Sister Wimberly Playground – Swan Lake

ITB #12 – 25/26

Addendum #2 – October 30, 2025

2 **SUBGRADE PREP FOR EWF**
L6.4 **ELEVATION 1"=1'-0"**

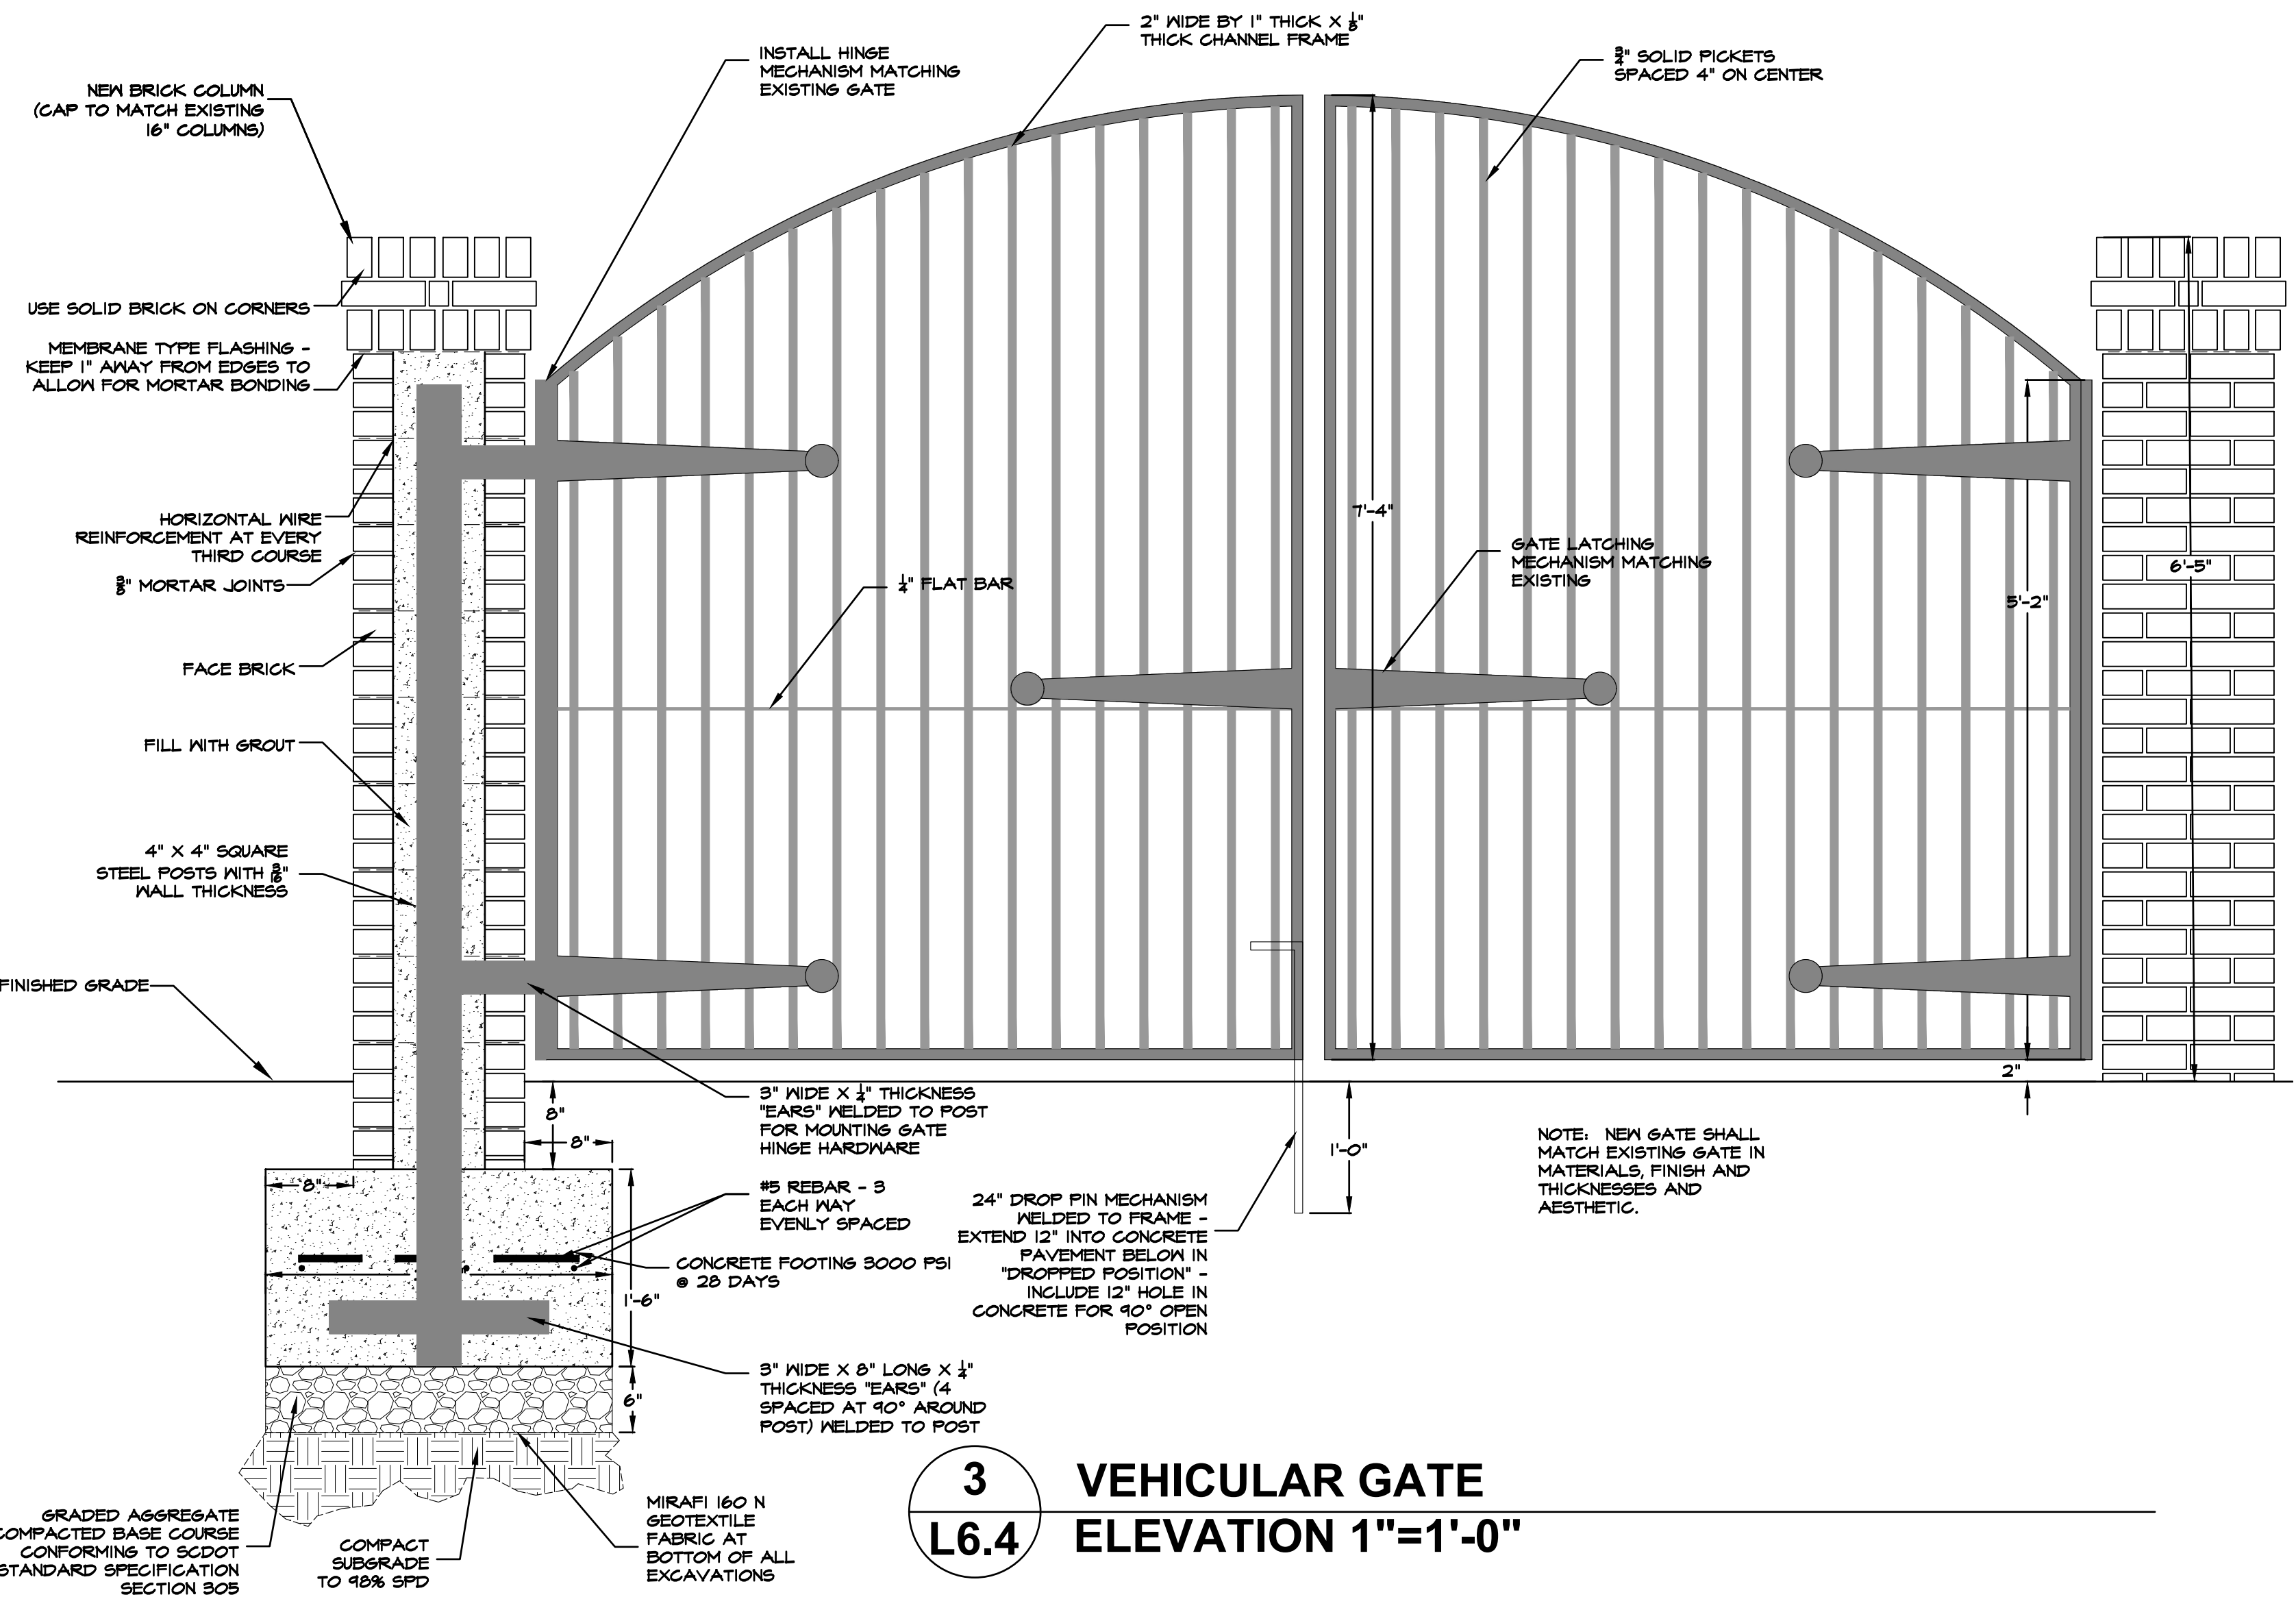
13. Refer to revised details 4 and 5 on sheet L6.1 and detail 2 on sheet L6.4 which clarify that stone below finished playground surfacing is to be installed by the playground installer after excavation and drainage installation by the contractor. Drainage installation by the contractor shall include #57 stone, pipe and geotextile fabric as detailed. Any items not labeled as “BY PLAYGROUND INSTALLER” or “BY OTHERS” shall be installed by the contractor.

- NOTES:**
1. AFTER EXCAVATION, THE GENERAL CONTRACTOR SHALL COORDINATE WITH THE PLAY EQUIPMENT INSTALLER FOR REVIEW OF SITE PREPARATION AND SHALL MAKE ADJUSTMENTS BASED ON THAT REVIEW AS DIRECTED BY THE PLAY EQUIPMENT INSTALLER.
 2. INSTALL CENTURY 2420 ROOT BARRIER BY CENTURY PRODUCTS (114-652-1055) AT LOCATIONS SHOWN ON PLAN - TOP OF ROOT BARRIER SHALL BE 4" BELOW TOP OF MULCH AND SURROUNDING GRADE.

L7.1

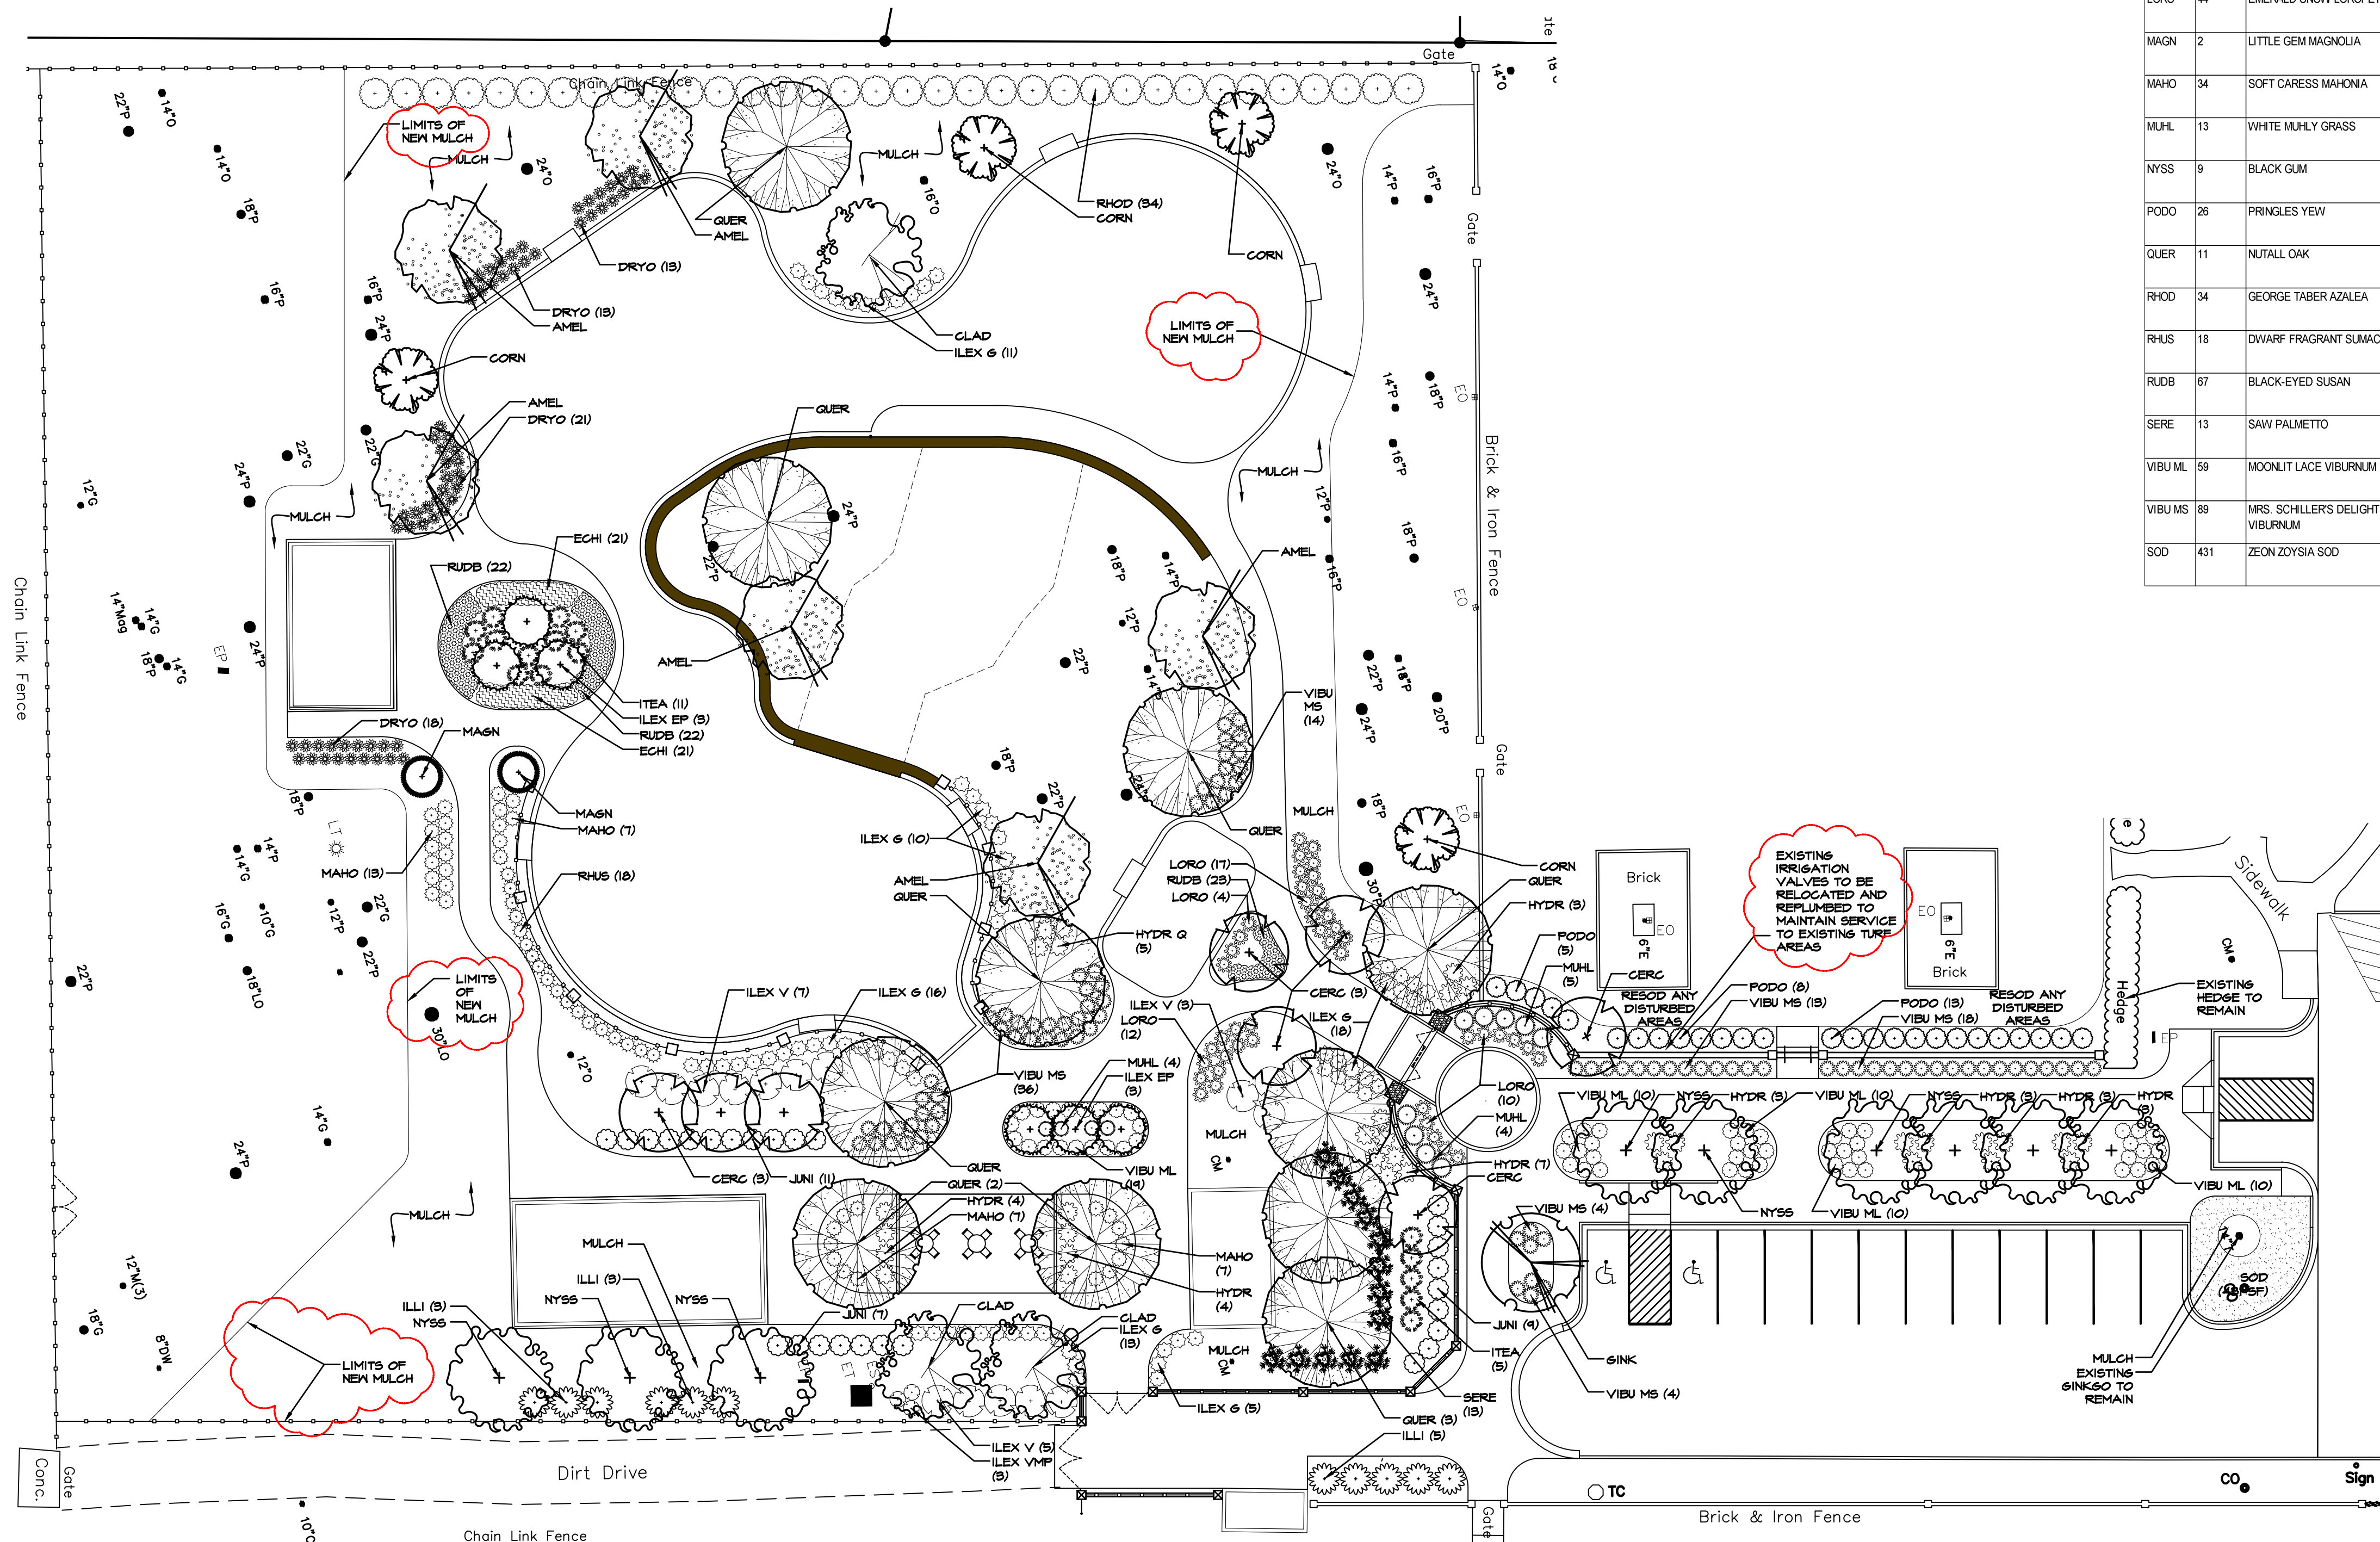
14. Refer to revised sheet L7.1 for limits of mulch within existing wooded areas.
15. Refer to revised sheet L7.1 for additional notes regarding the existing irrigation system.
